BN/13/15/PL

PLAN-009832

Proposal: Demolition of existing shed/garage & erection of 1 No. detached dwelling.

Site: Saxons 33 Hill Lane, Barnham, PO22 0BL.

Southern Water MapGuide Browser

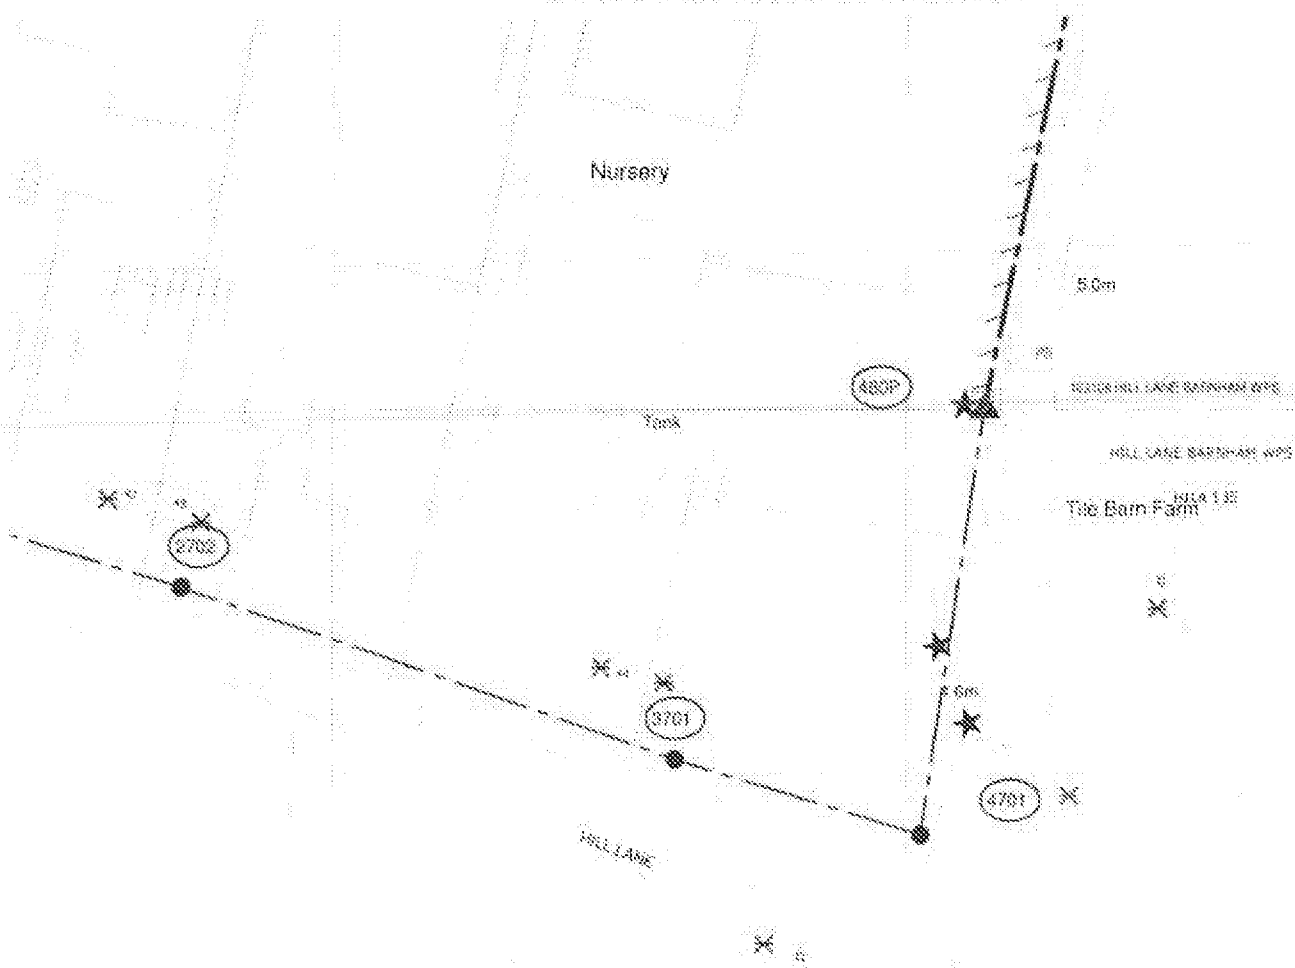
Due to changes in legislation that came in to force on 1st October 2011 regarding the future ownership of sewers it is possible that a sewer now deemed to be public could be crossing the above property. Therefore, should any sewer be found during construction works, an investigation of the sewer will be required to ascertain its condition, the number of properties served, and potential means of access before any further works commence on site.

The positions of pipes shown on this plan are believed to be correct, but Southern Water Services Ltd. accepts no responsibility in the event of inaccuracy. The actual positions should be determined on site.

The applicant is advised to discuss the matter further with Southern Water, Sparrowgrove House, Sparrowgrove, Otterbourne, Hampshire SO21 2SW (Tel: 0330 303 0119) or www.southernwater.co.uk.
